From: Andrews, David
Sent: Tuesday, January 24, 2012 3:45 PM
To: 'Nikolai_Amortegui@oxy.com'
Cc: Simon_Benevides@oxy.com; Nicolas_Carestia@oxy.com; Brad_Ahlquist@Oxy.com; Joan_Proulx@oxy.com; Chris_Clark@oxy.com; Daniel_Padilla@oxy.com; Edelen, Randy
Subject: RE: OXY/697-04-82/PAD 697-04D AP I050452072800. Side track approval
Attachments: CC 697-04-82 ST-1 Plan 2.pdf; MM Diameters.jpg; MM Diameters 2.jpg; HP 330 04-82 Surveys 1.16.2012.pdf; Industry Guidance UNPLANNED Sidetrack Approval & Reporting Rev 09-22-2011.pdf

Subject: OXY/697-04-82/PAD 697-04D AP I050452072800

Operator:	OXY USA
Well Name:	CC 697-04-82
Legal Description:	Sec 4 Town 6S Range 97W
COGCC #	66571
API#	050452072800
Rig Name and Number:	H&P 330
OXY Supervisor	VICTOR BENAVIDES/DEREK ADAM
Phone number at rig:	281-436-6424

Drill Motor Fishing Dimensions

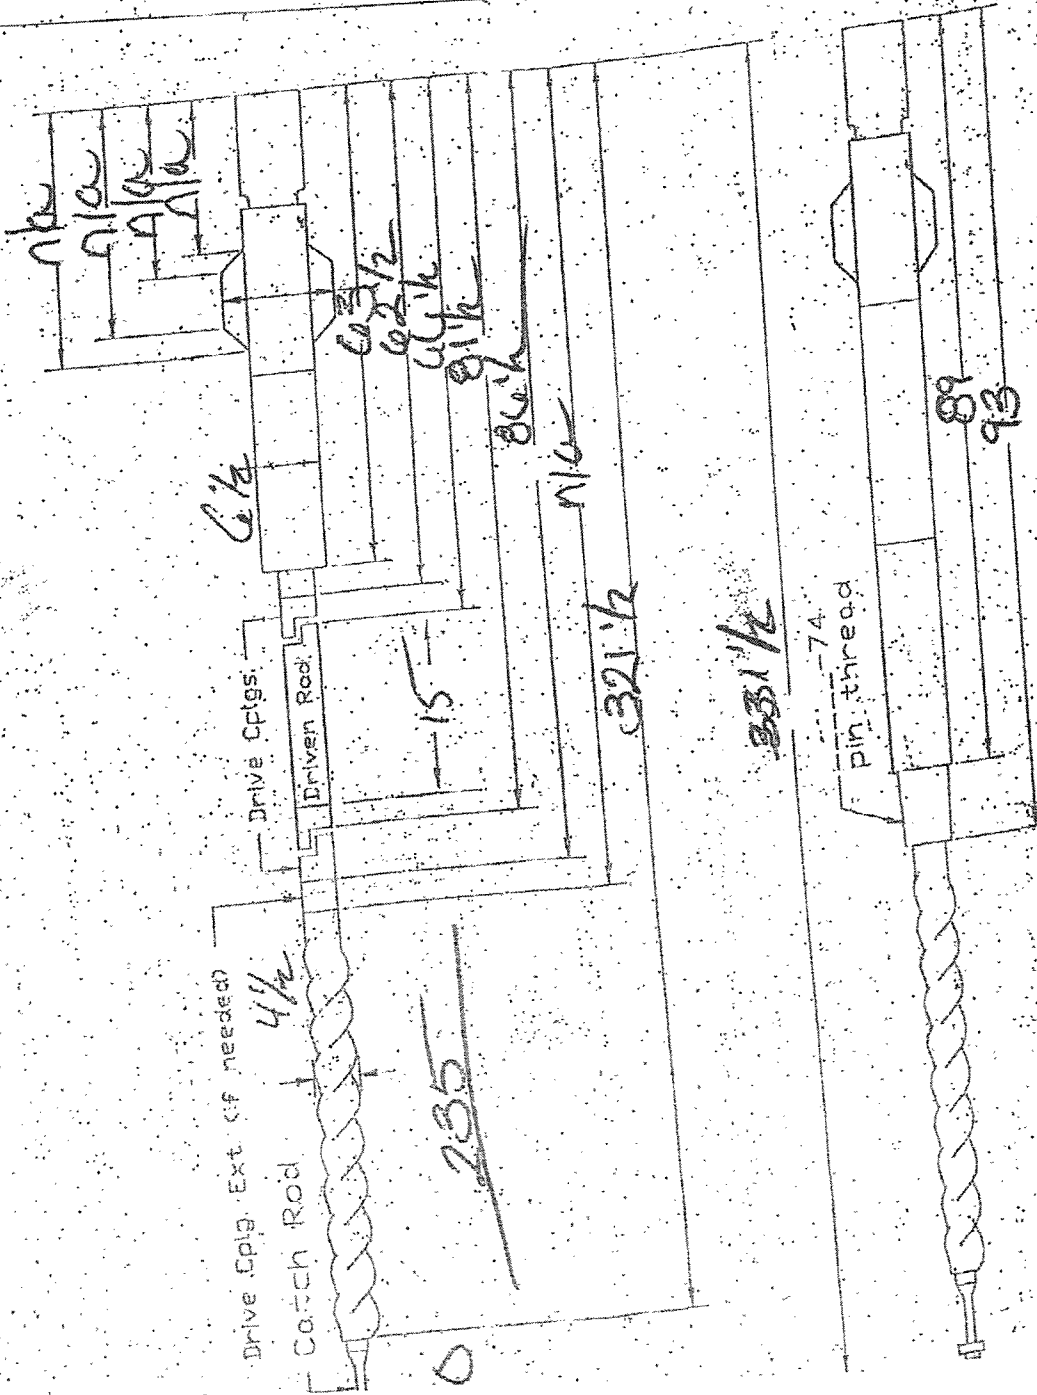
4. Fish long. (attach)

- Mud motor 30.09 ft
- Bit 2 ft
- Total fish 32.09 ft

- Top of the fish 4830'
- Bottom 4862.09
